**MEETING NOTICE – SITE REVIEW COMMITTEE**

**5. DISCUSSION AND ACTION - 582 Larsen Orchard Pkwy, HB-3260; New 4-story 25,380 Square Foot Mixed Use Commercial/Retail/Residential Building (Page 3)**

**RE:** 582 Larsen Orchard Pkwy, HB-3260; New 4-story 25,380 Square Foot Mixed Use Commercial/Retail/Residential Building

**ISSUE:** Discussion and action on a new 4-story 25, 380 Square Foot Mixed Use Commercial/Retail/Residential Building and associated site improvements

**NORTH ELEVATION**

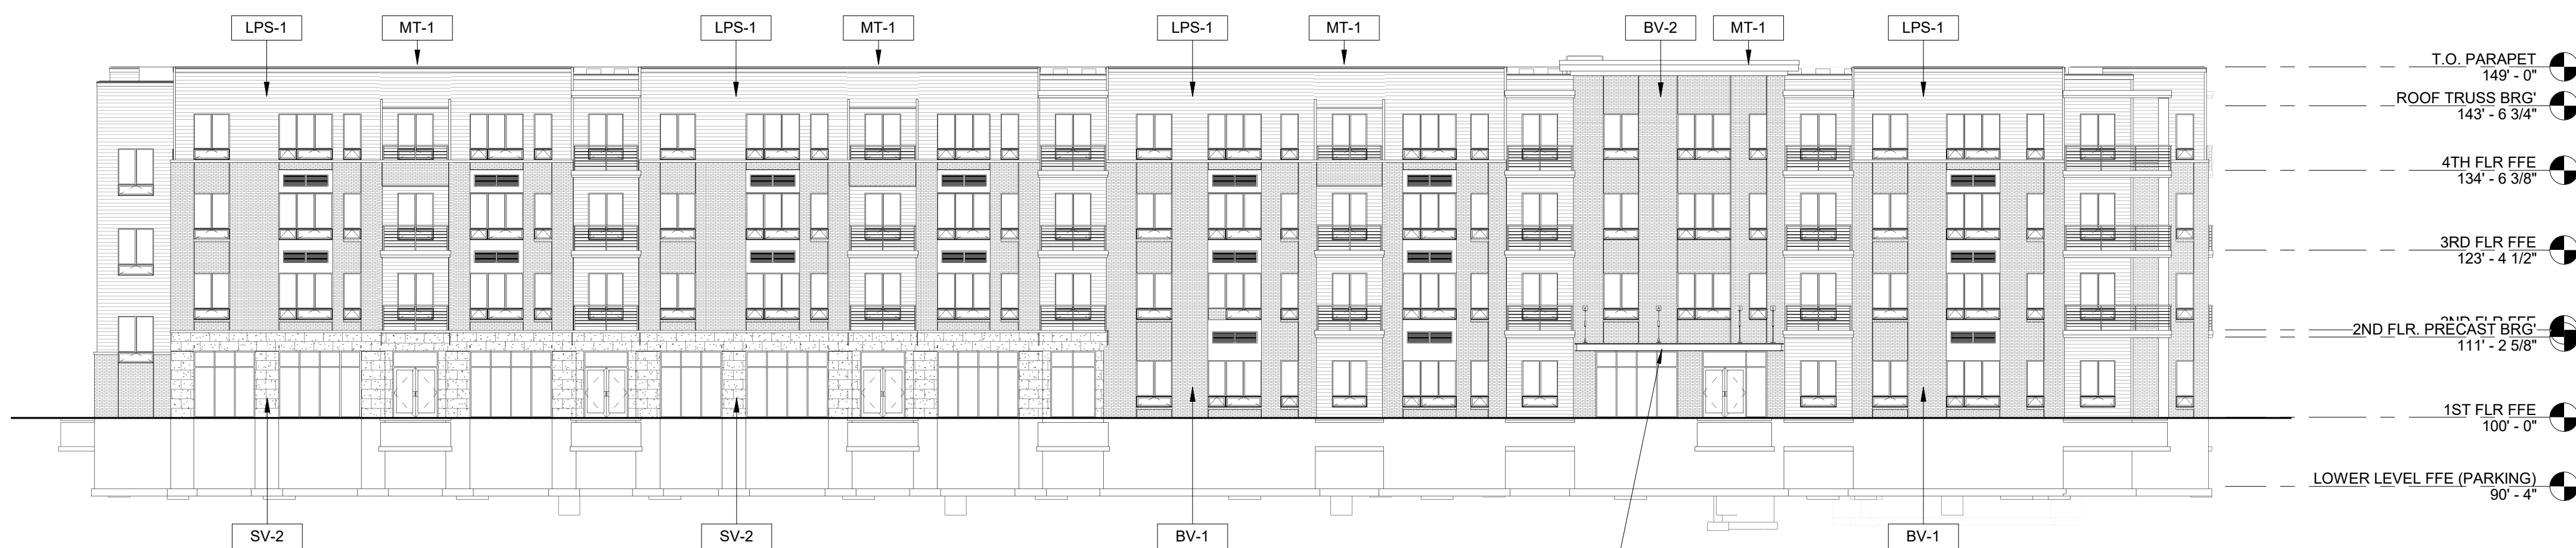
- 1. Exterior Materials:** Proposed building materials consist of a mixture of brick and stone veneer and horizontal lap LP Smart siding. These materials will be consistent on all four building elevations.
- 2. Height:** 149' to top of parapet wall
- 3. Overhead doors:** Only overhead door will be on the north elevation to access the underground parking area.
- 4. Mechanical equipment:** Mechanical equipment to be screened by parapet walls where roof mounted. Dwelling units will have individual furnaces with only a vent grill will be visible from the exterior. This vent grill shall be required to match the building colors.

- 1. HVAC grills shall be colored to match the building façade where they are located.
- 2. Obtaining easement from adjoining property owner for installation of driveway from Founders Ter.
- 3. Any additional mechanical equipment, if located on the roof or ground, shall be screened from view by materials compatible with the building or landscaping.
- 4. Location of FD connection and lock box(s) shall be approved by the Fire Chief prior to installation.
- 5. Developer shall discuss door access and locking with the Police Chief during construction to ensure that access to portions of building are not available to all patrons.

OVERALL SITE PLAN

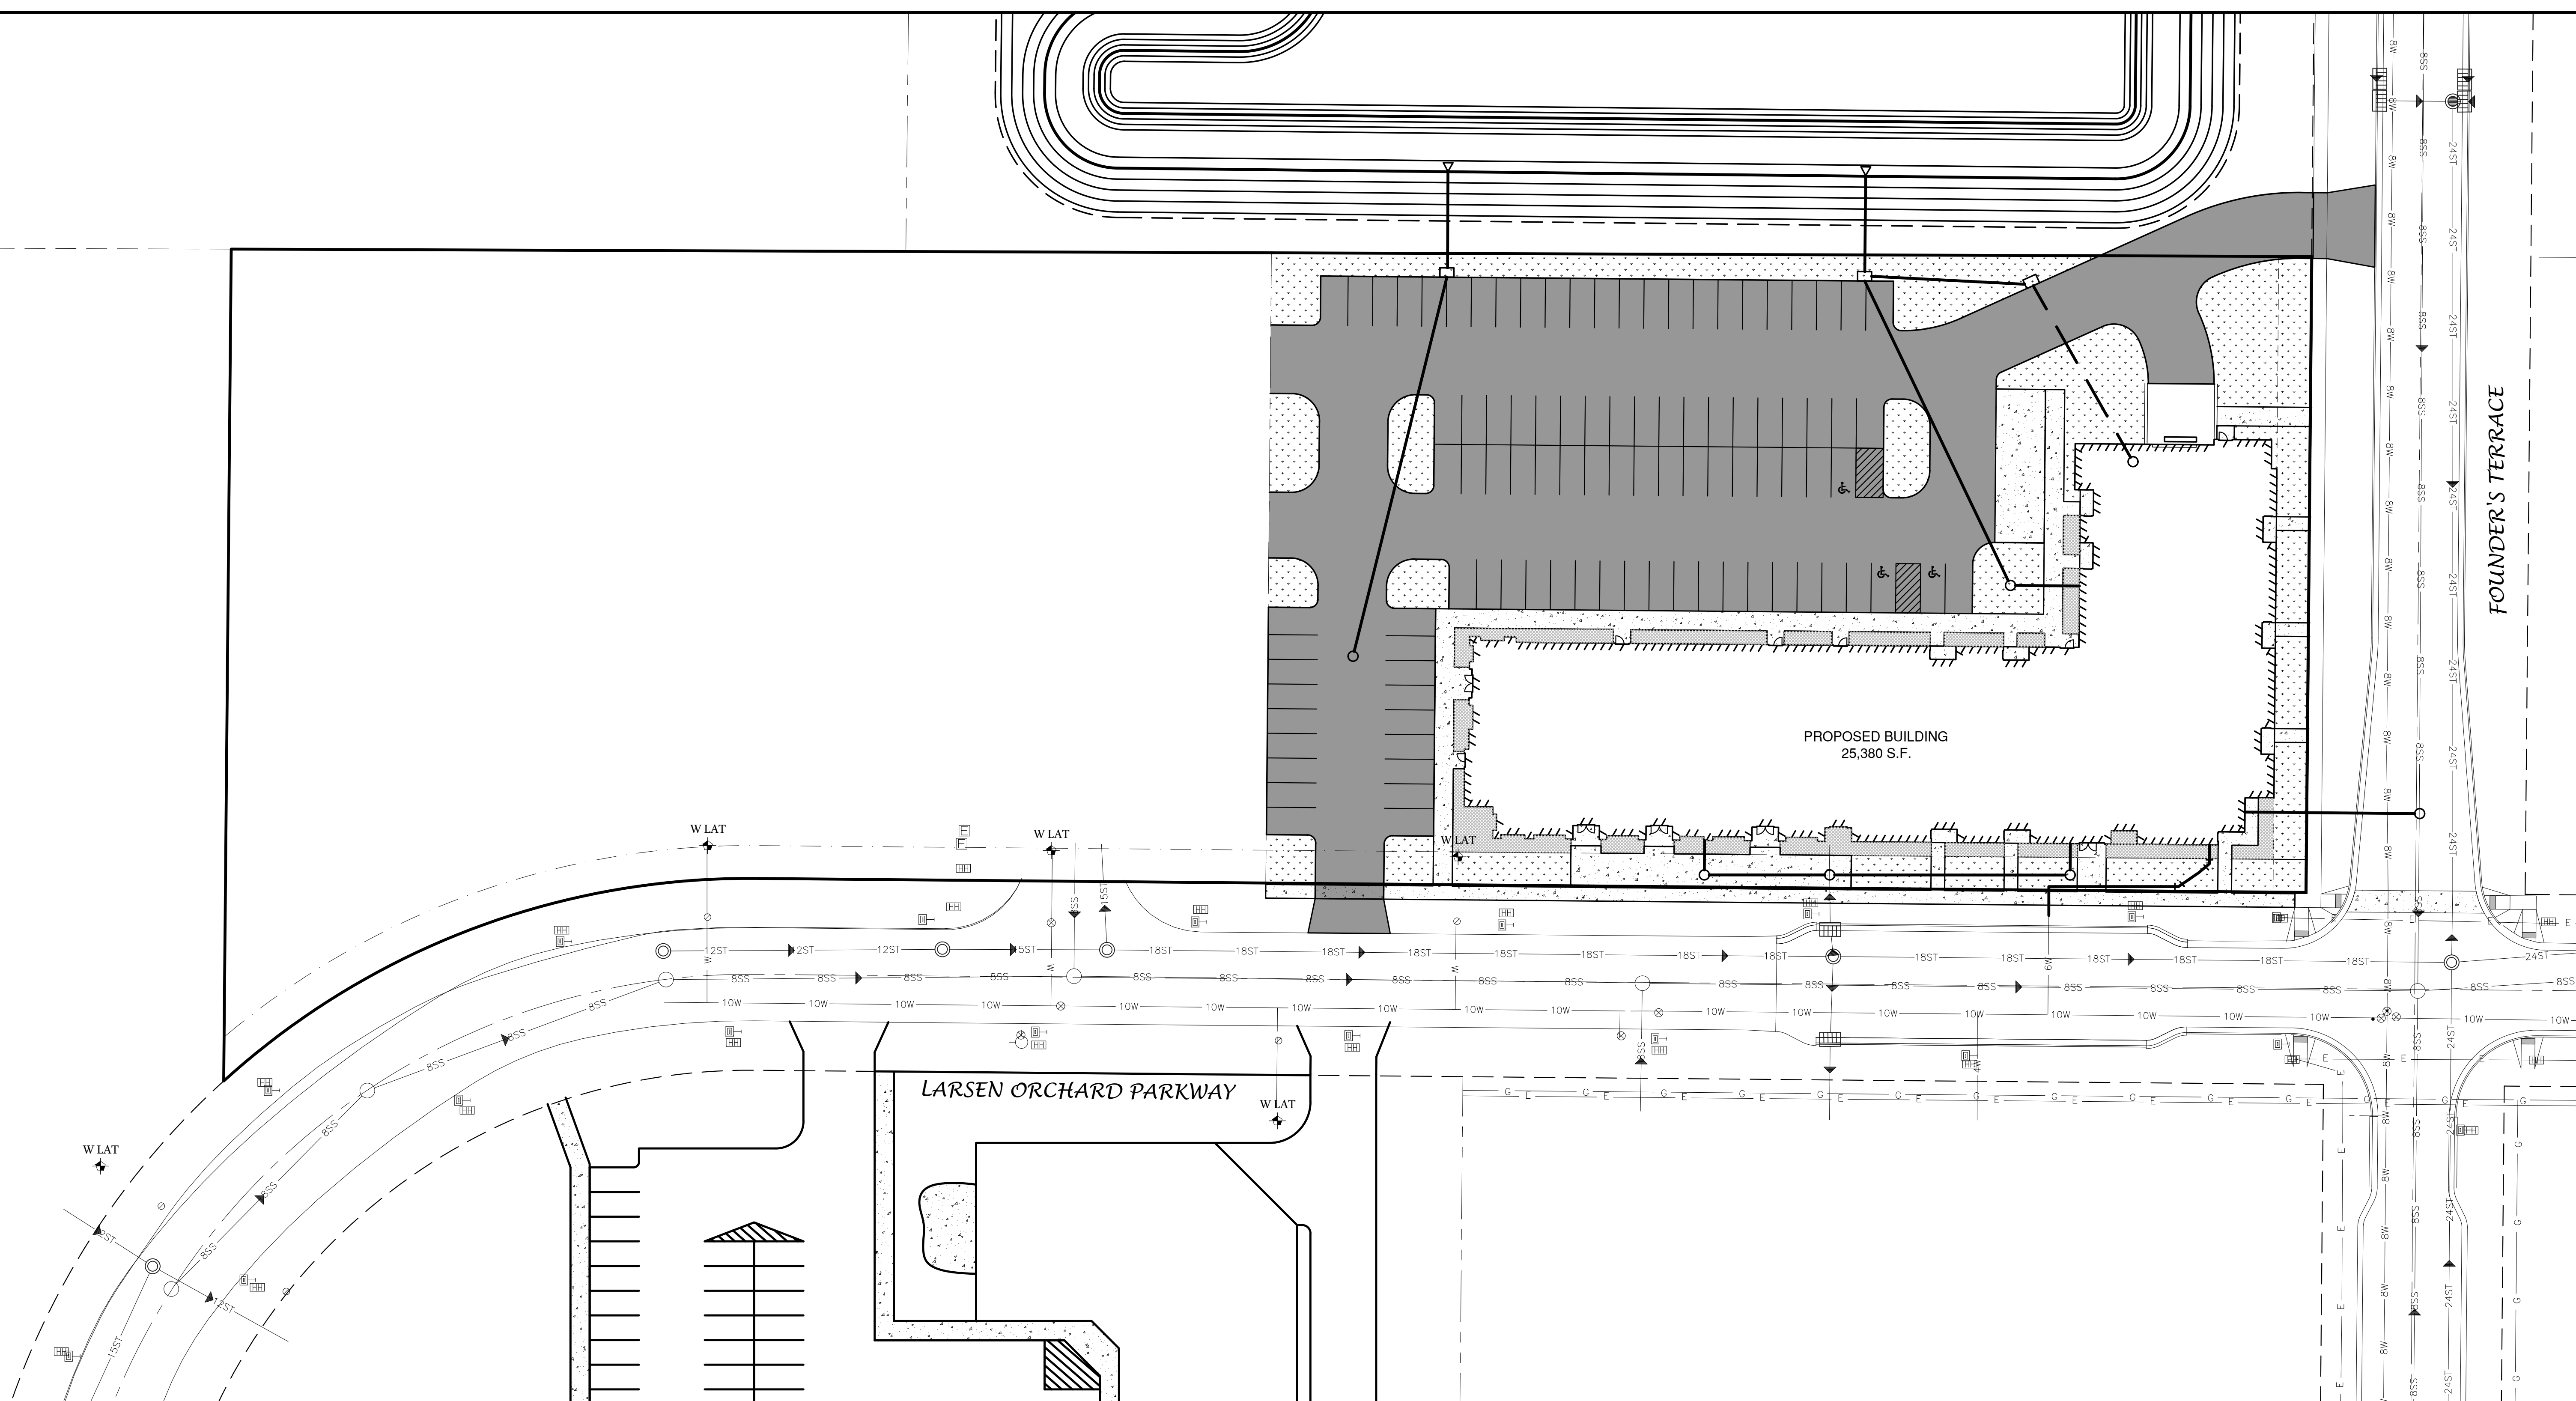
- A. Zoning:** PDD #1: Centennial Centre at Hobart District
- B. Green Space:** 15% green space proposed (10-25% required by code).
- C. Setbacks:** Per the PDD #1 zoning district, “minimum setbacks will be established per the design of the structure”. Front setback along Larsen Orchard Pkwy – 21’ (front of building), 12.5’ to east property line (second building front facing Founders Ter.), 71’ to west property line, and 65’ to north property line. All comply with zoning requirements.

- D. Parking:** 159 standard spaces proposed (93 surface and 66 underground) and 6 ADA spaces (3 surface and 3 underground) for a total of 165 spaces. 159 spaces are required per code of 1 and half for each dwelling unit (66 units) plus 1 space for each 4 units for guests 116 required), and 1 space for each 300 square feet of business space (9,714 square feet of business area) plus 1 space for each staff member of a business (estimated at 2 staff members per business) (43 required).

**Section 6, Driveway-Curb Cut:** Access to this site will be through two separate driveways. The driveway from Larsen Orchard Pkwy will be 25' with a curb cut of 30'. The second driveway from Founders Ter. will be 24' with a curb cut of 30' This driveway from Founders Ter. will require an easement from the adjoining property owner prior to installation.

FILE: P:\2020\2025\20250530\445\BASE MAP.dwg  
PLOT DATE: Sep 13, 2024 7:31 AM  
SITE  
LAYOUT

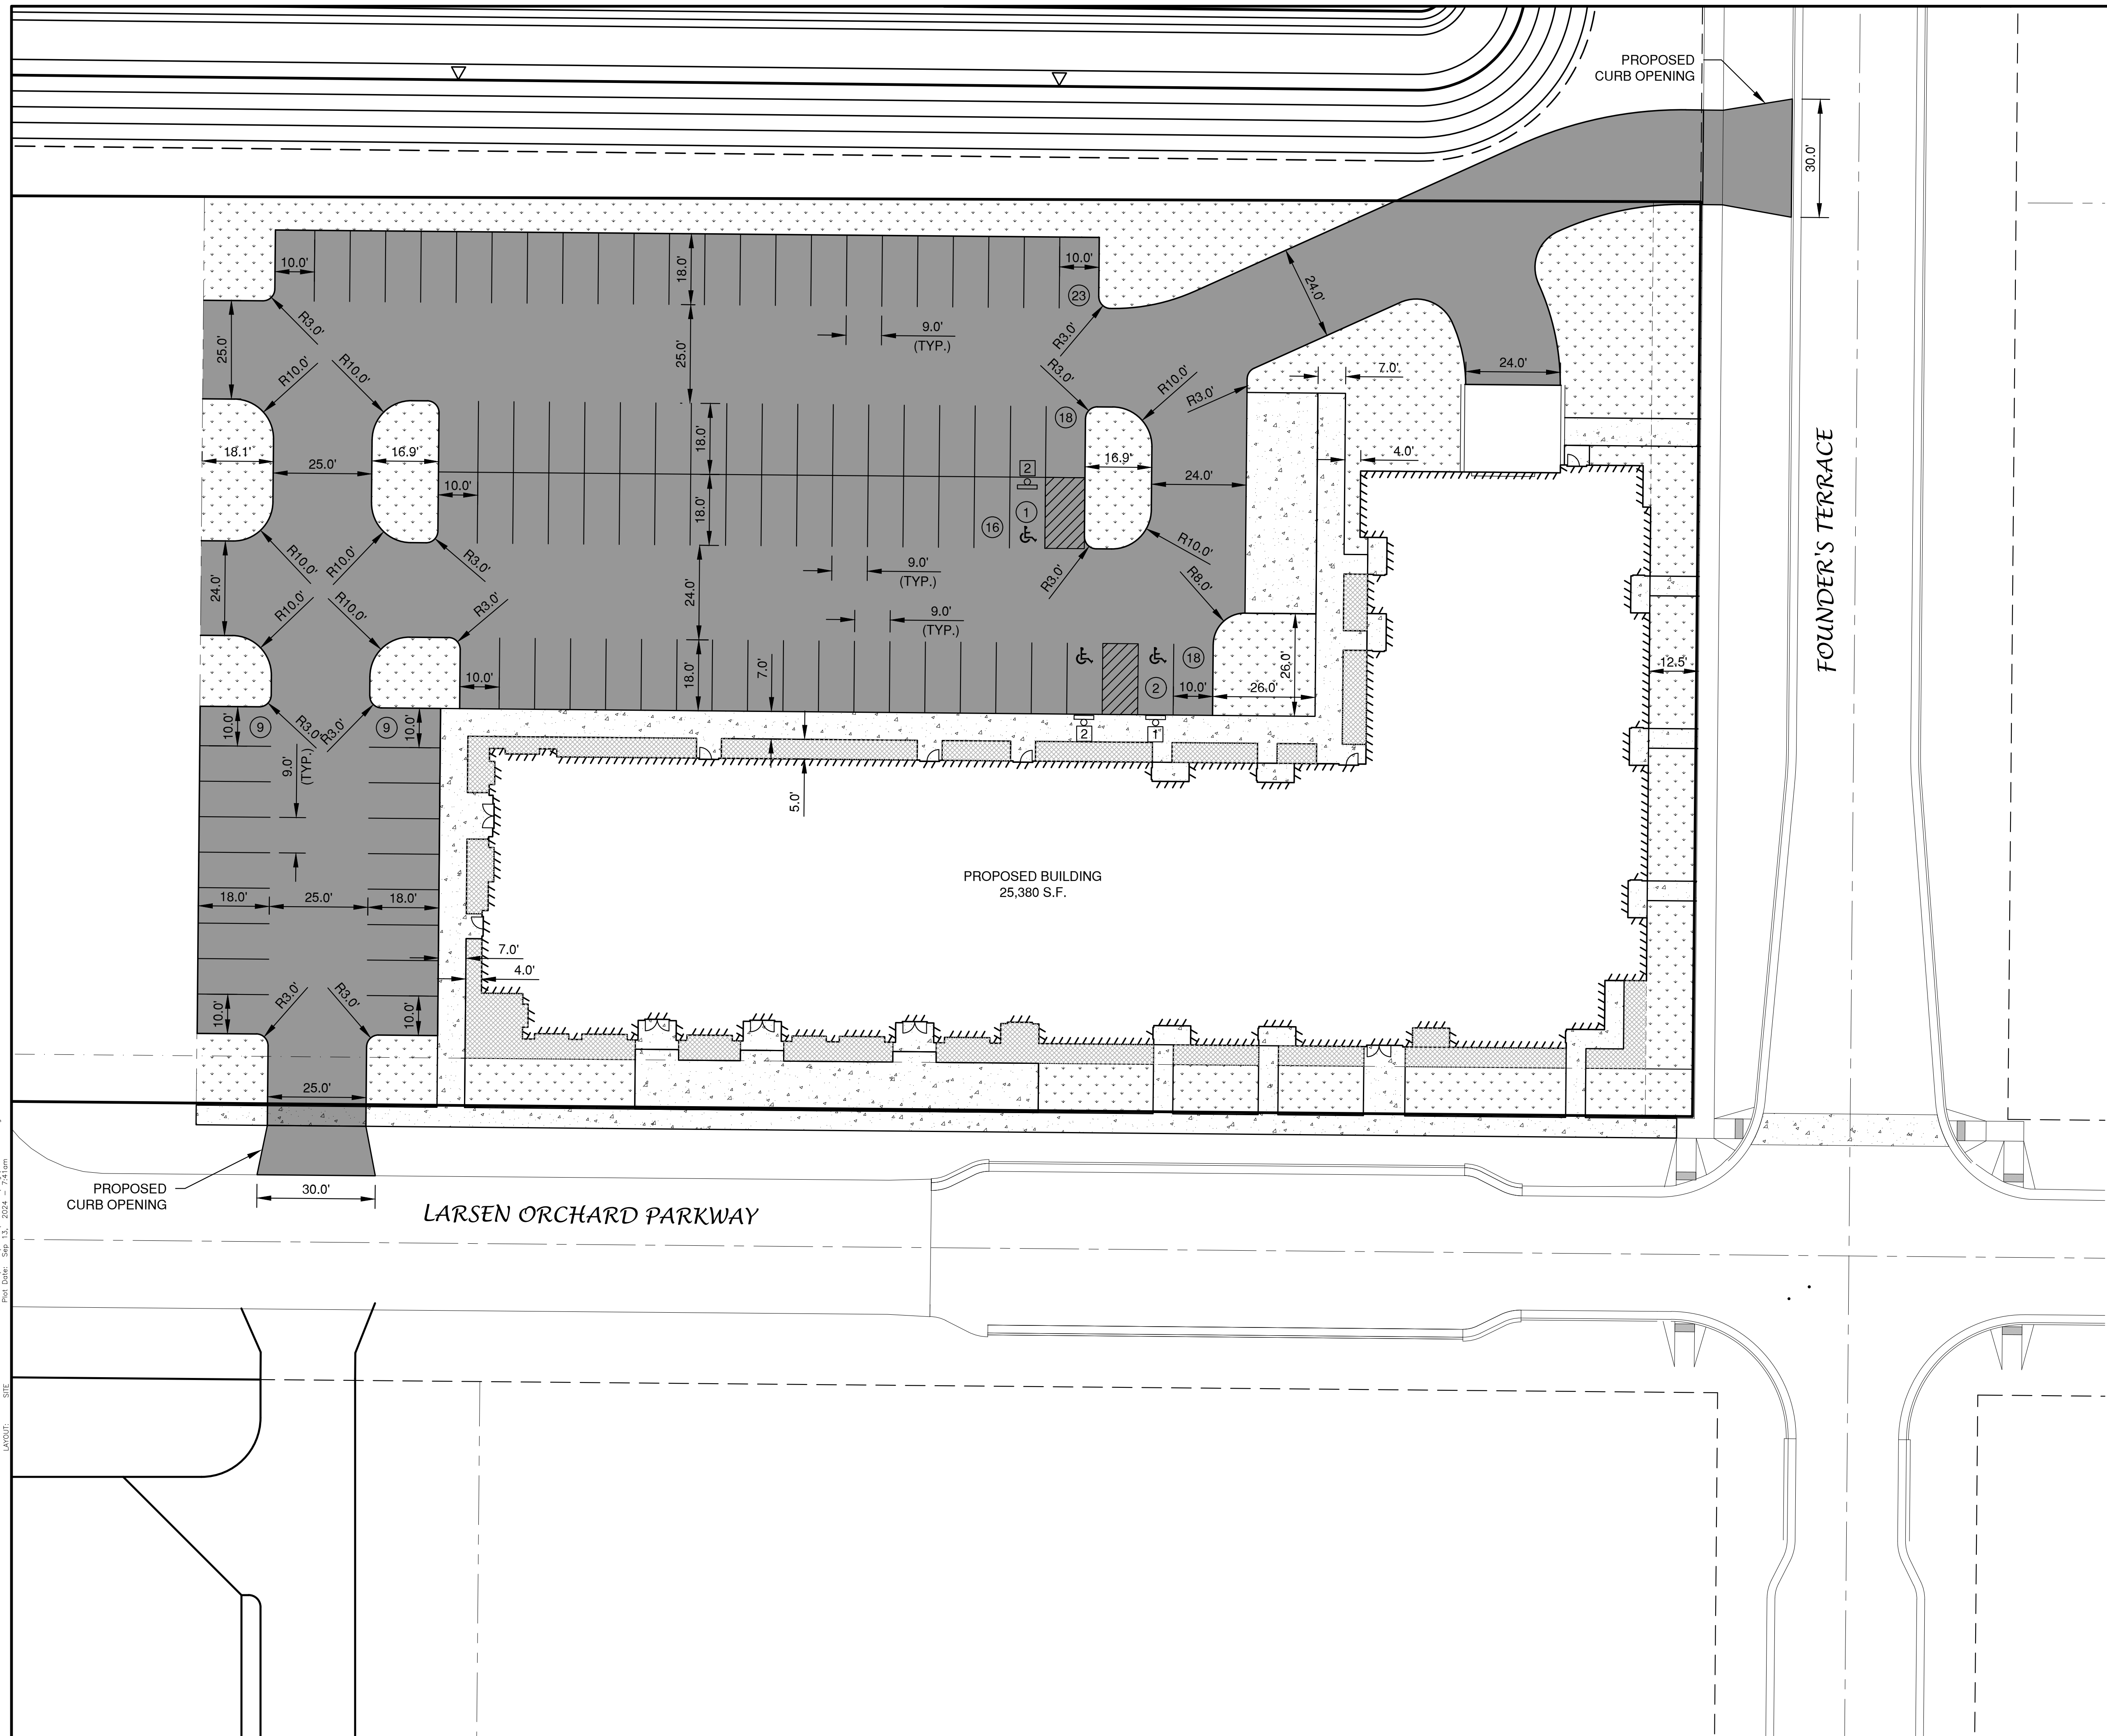
- F. Storm Water:** Storm water running off the proposed building and parking areas will be collected by the proposed on-site storm sewer and will be discharged to the existing Centennial Centre regional storm water wet detention pond on the property to the north which is owned by the Village of Hobart and design for such storm water purposes.
- G. Utilities:** Any new sewer/water taps into the public system that are required for this development shall be reviewed and approved by the Village Public Works Department prior to excavating and installation.
- H. Refuse Collection:** The Refuse/recycling is proposed to be stored in the underground parking area and brought out on day of collection. Any future plan to locate the storage outdoors would require submittal and approval by the SRC prior to construction.

6. Landscape plan shall be submitted for approval prior to installation.
7. Signage details shall be submitted for approval prior to installation.
8. Any new sewer/water taps into the public system that are required for this development shall be reviewed and approved by the Village Public Works Department prior to excavating and installation.
